REF: SPR-8-24
DATE: April 11, 2024

| Request | - | Major Site Plan Review for expansion of intermodal facility |
| Location | - | 127 S Westwood Avenue |

MAJOR SITE PLAN REVIEW
TOLEDO CITY PLAN COMMISSION
REF: SPR-8-24
DATE: April 11, 2024
TIME: 2:00 P.M.

STRIPING, BARRIER, AND FENCING AREA 2

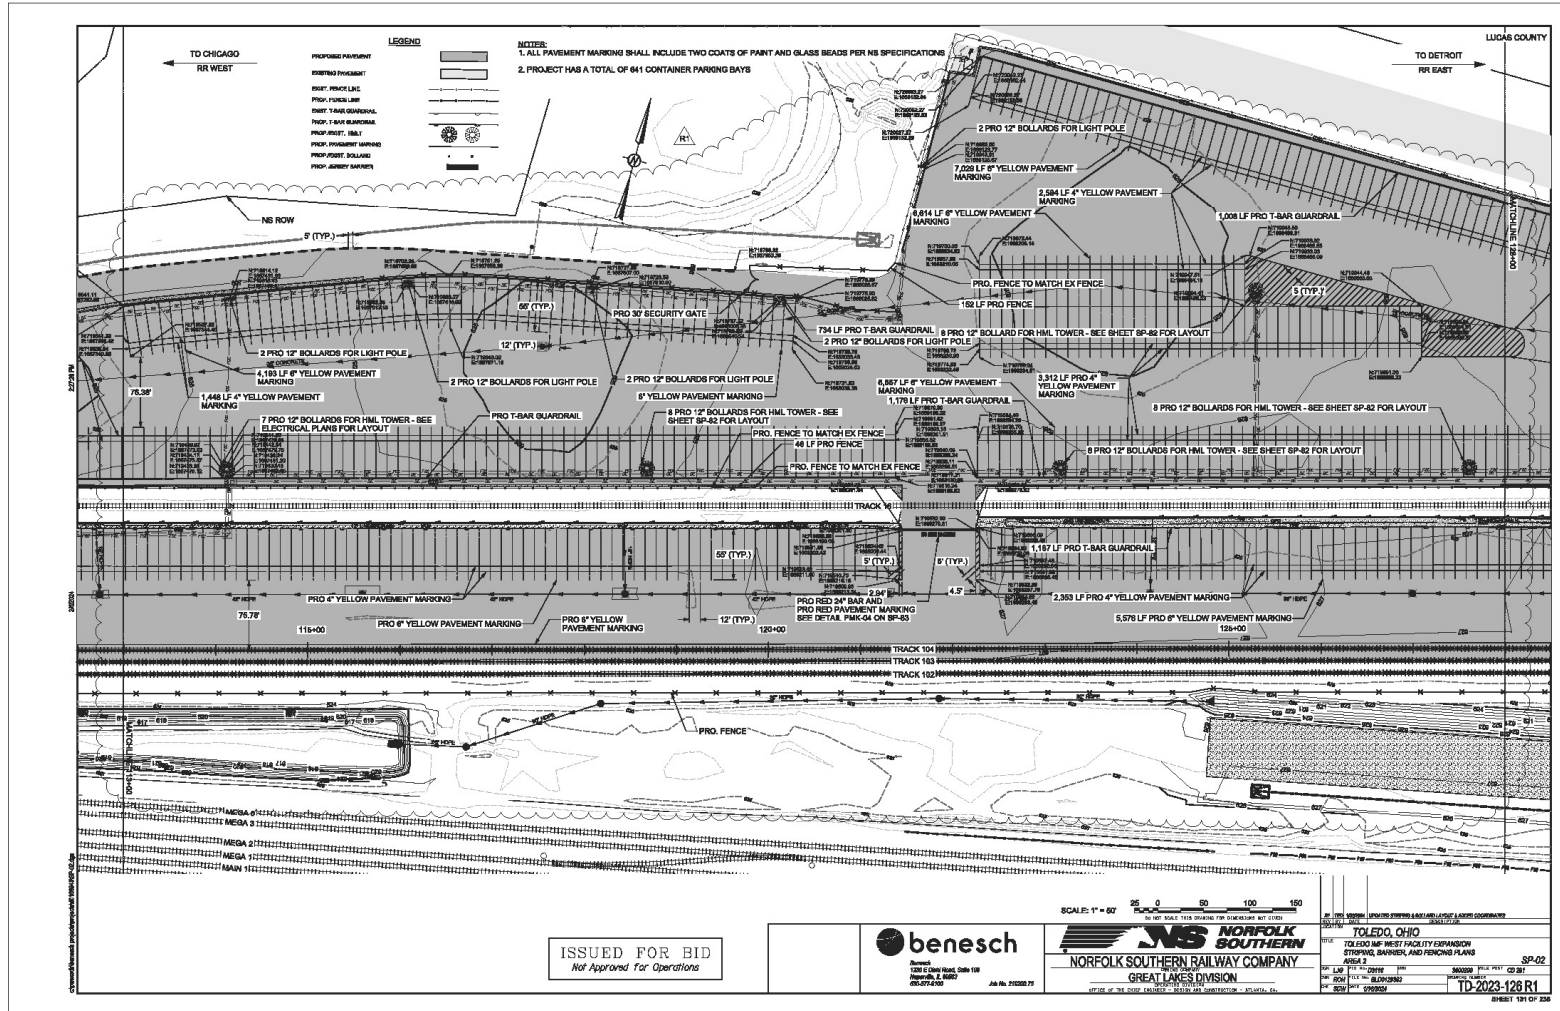
Pursuant to the Americans with Disabilities Act and TMC§1107.1700 *Accessible Parking for Physically Disabled Persons*, one van and one auto accessible parking space is required with 8' loading aisle for van and 5' loading aisle for auto in the 40-space parking lot along S Westwood Ave. The current site plan shows none. Accessible parking must be signed and marked in conformance with TMC§1107.1704 *Signs and Marking*.

The use of barbed wire, razor wire, concertina wire, electric fences or the like are not permitted anywhere along a street right-of-way. The fence and gate along S Westwood Avenue may not use barbed wire like currently depicted. Other sides of the fence surrounding the employee parking lot may use barbed wire as depicted.

23. A detailed site, fencing and landscaping plan shall be submitted to the Plan Director for review and approval. Such plans shall include:
 - a. Pursuant to TMC§1107.1700, a minimum of one (1) auto accessible and one (1) van accessible spaces shall be provided. **Not acceptable as depicted.**

- e. Barbed wire, razor wire, concertina wire, electric fences or the like are not permitted anywhere along a street right-of-way. **Not acceptable as depicted. Fence & gate along S Westwood Ave may not use barbed wire.**
